**APPENDIX 4B**

**DETAILED DRAWINGS FOR THE 200 AREA EFFLUENT TREATMENT FACILITY  
CONTAINER STORAGE AREA AND TANK SYSTEMS**

1. ECN 647892

CHANGES/ADDITIONS ARE SHOWN IN CLOUDED AREA. MODIFY DRAWING AS SHOWN IN CLOUDED AREA.

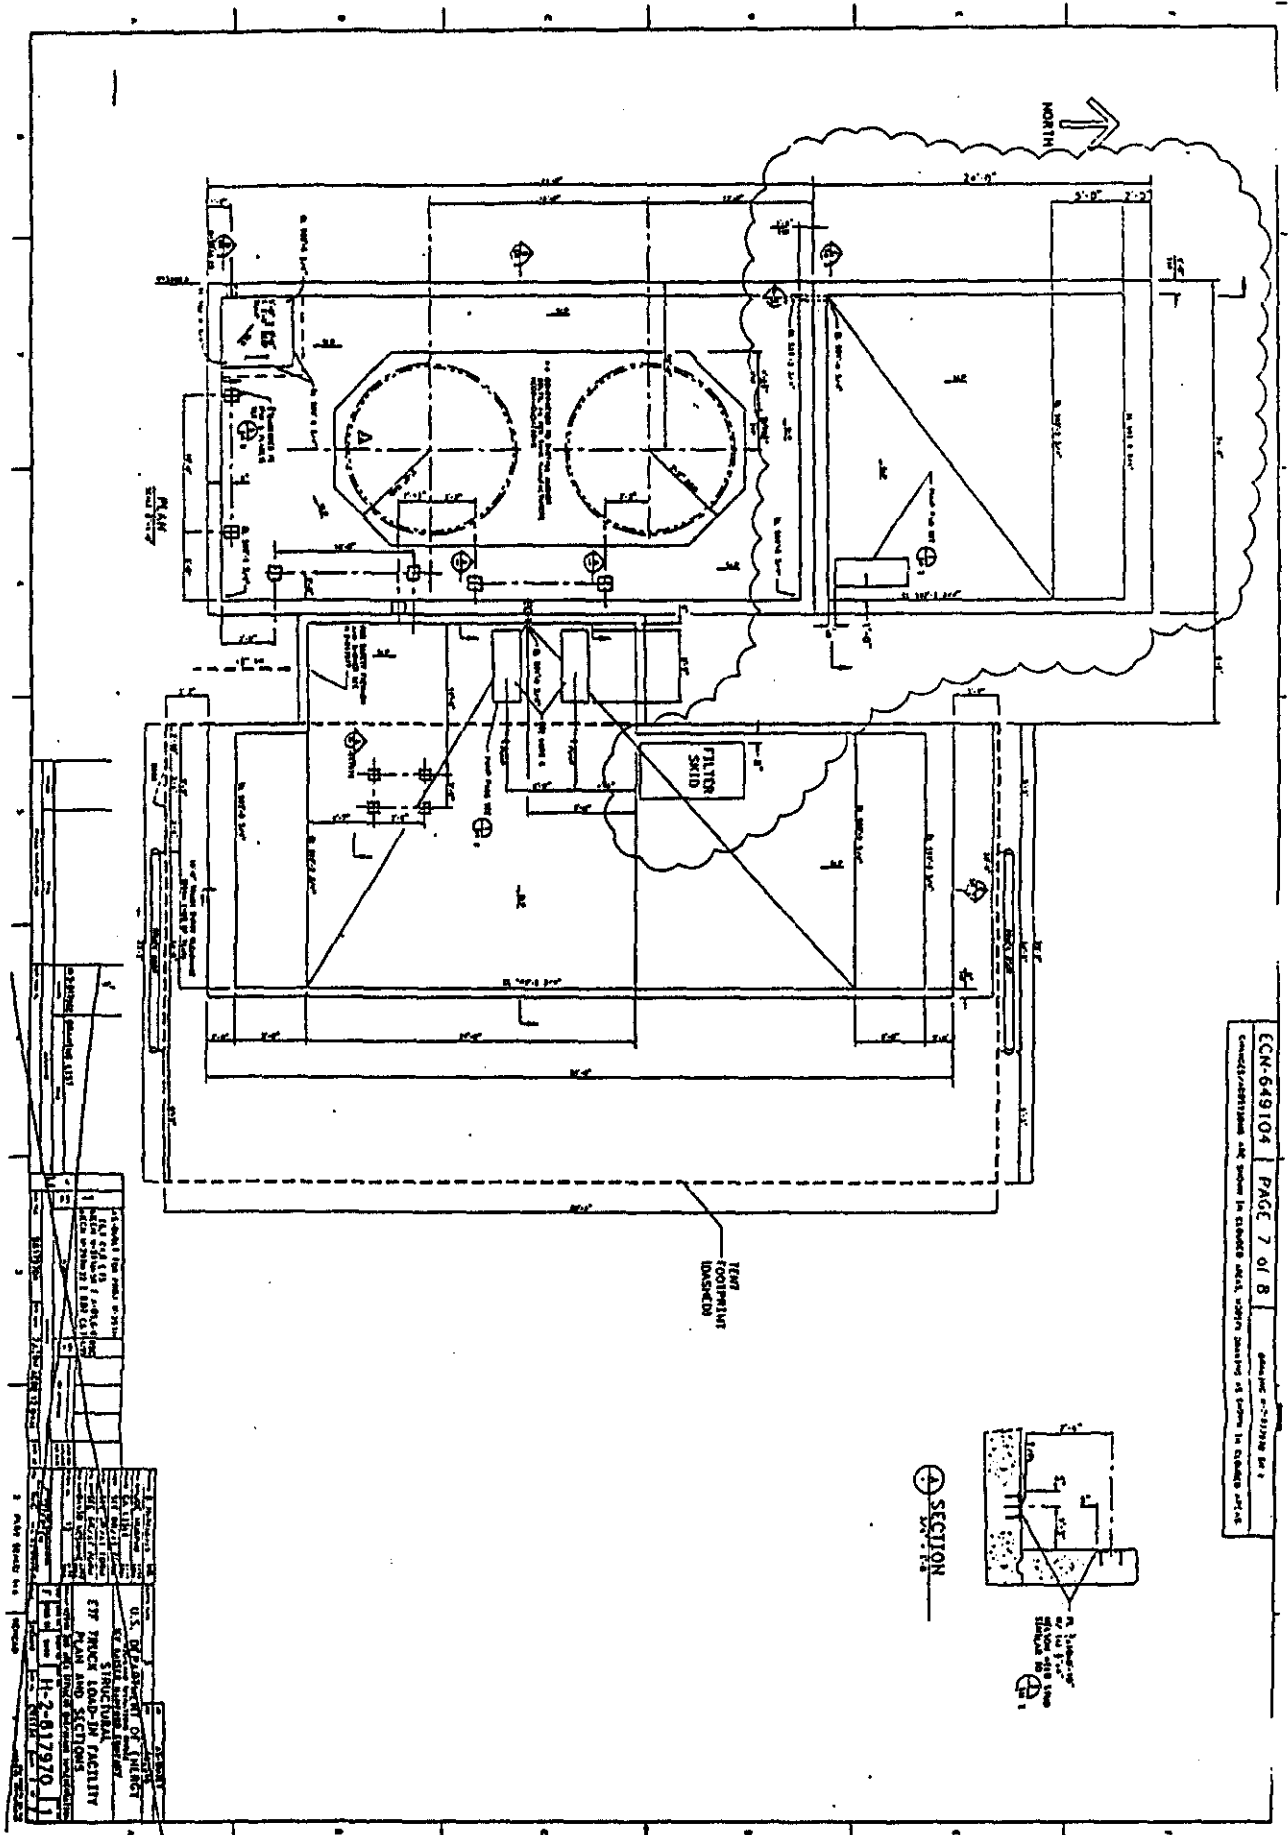
Zones C/F-5/8: Add asphalt and concrete pad areas, filter skid, pump base, dimensional details and Section G reference.

Zones A/D-4/8: Add Sections F and G and Detail 6. Add note to Section E identifying elevations of respective pump pads.

CHANGES/ADDITIONS ARE SHOWN IN CLOUDED AREA, MODIFY DRAWING AS SHOWN IN CLOUDED AREA..

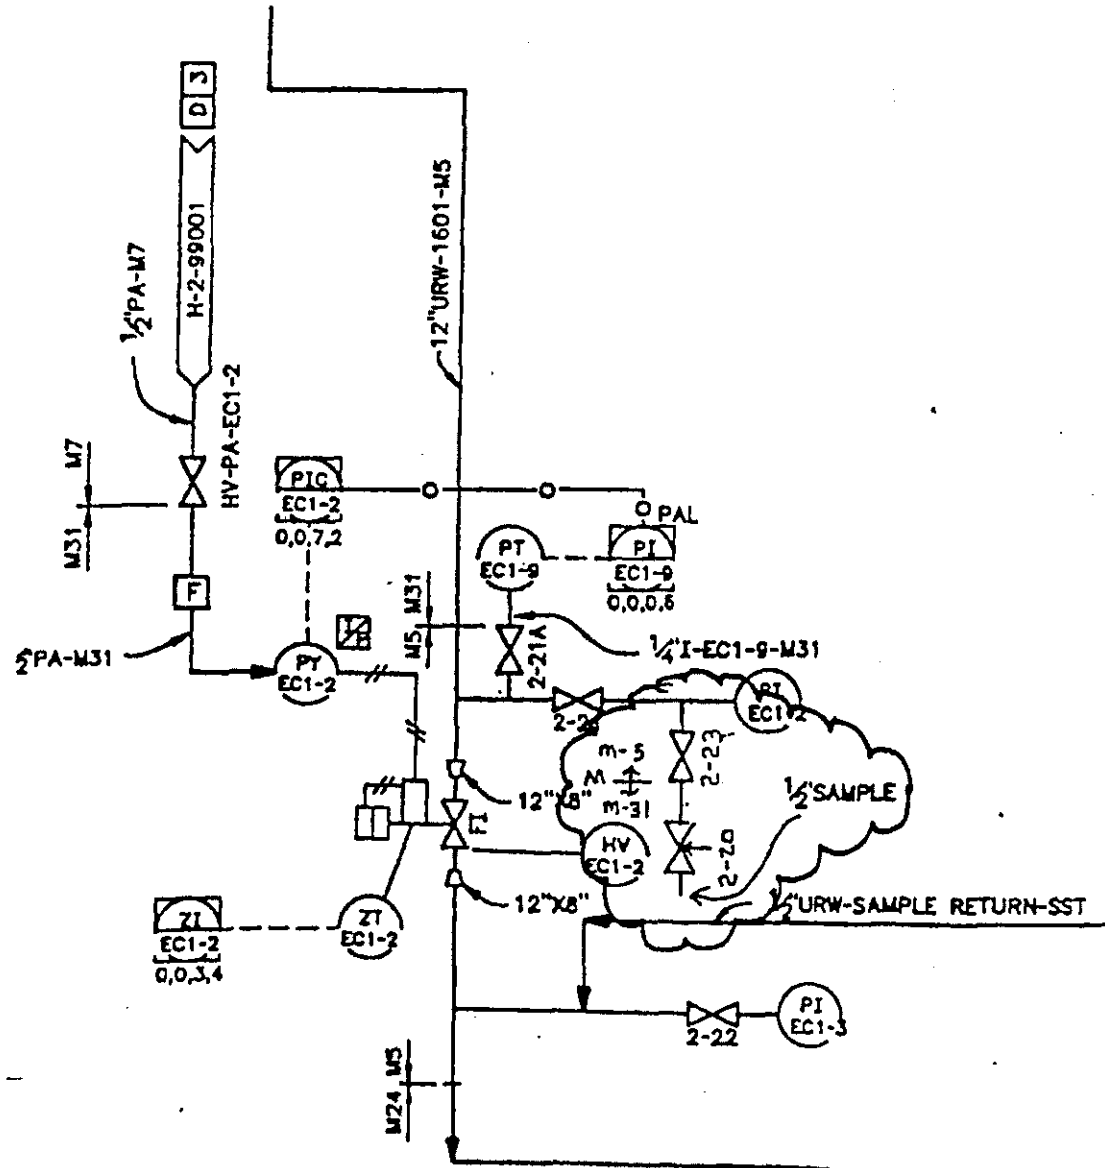
ON H-2-98994, SH 1, REV. 10, ZONE B-7, MODIFY SAMPLE VALVING AS SHOWN IN CLOUDED AREA, BELOW:

H-2-99002 Sh.1 Rev5

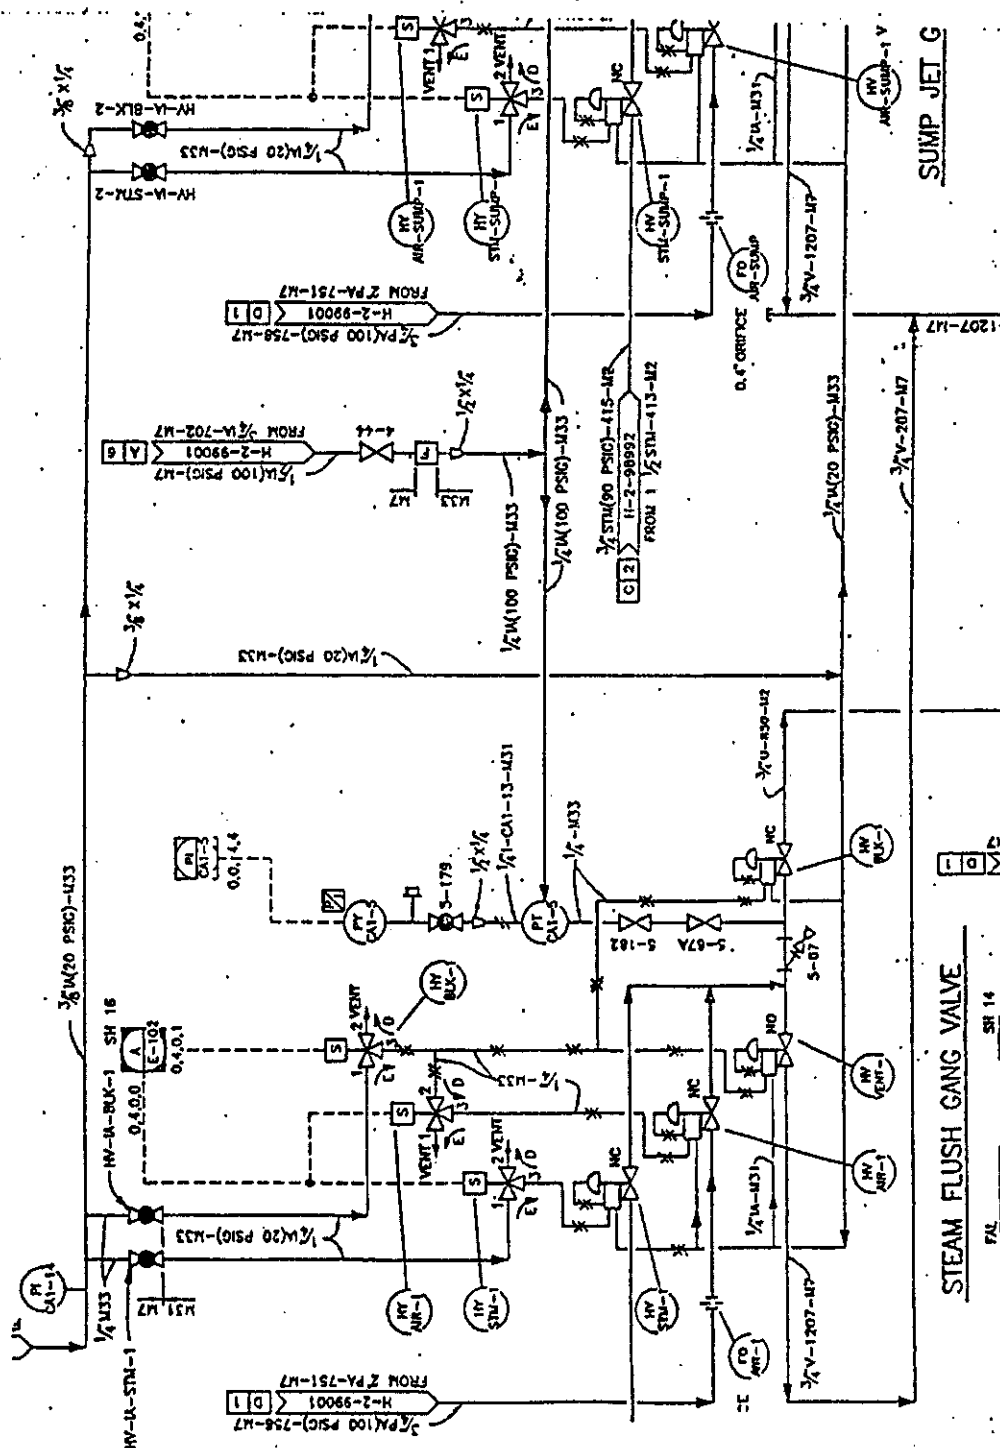
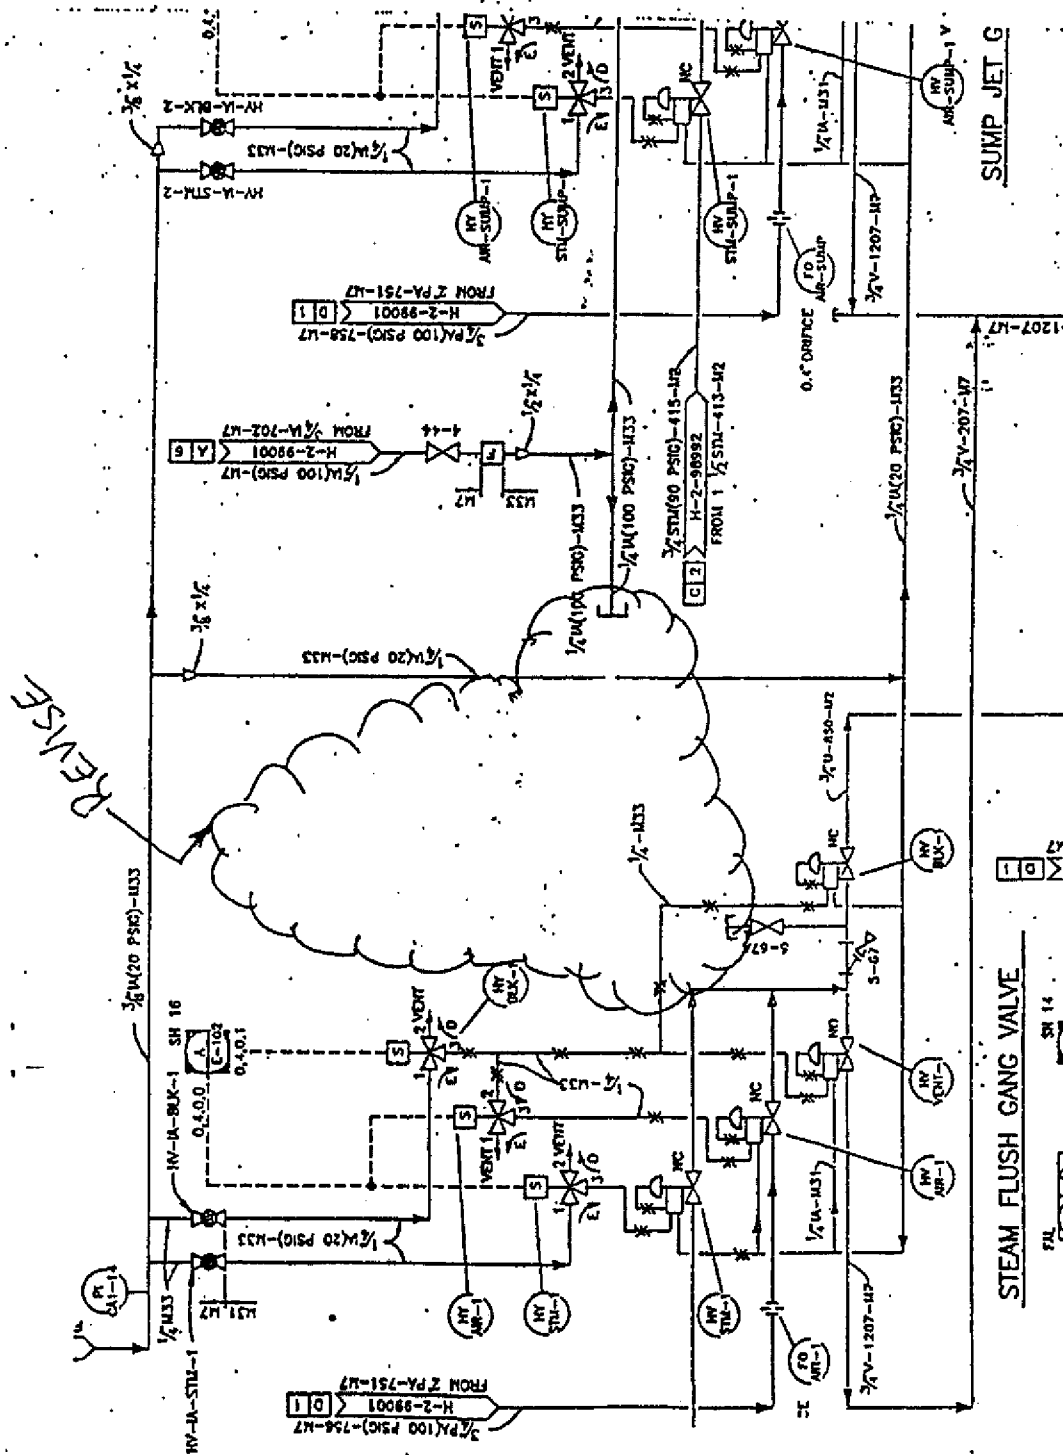
WAS

IS
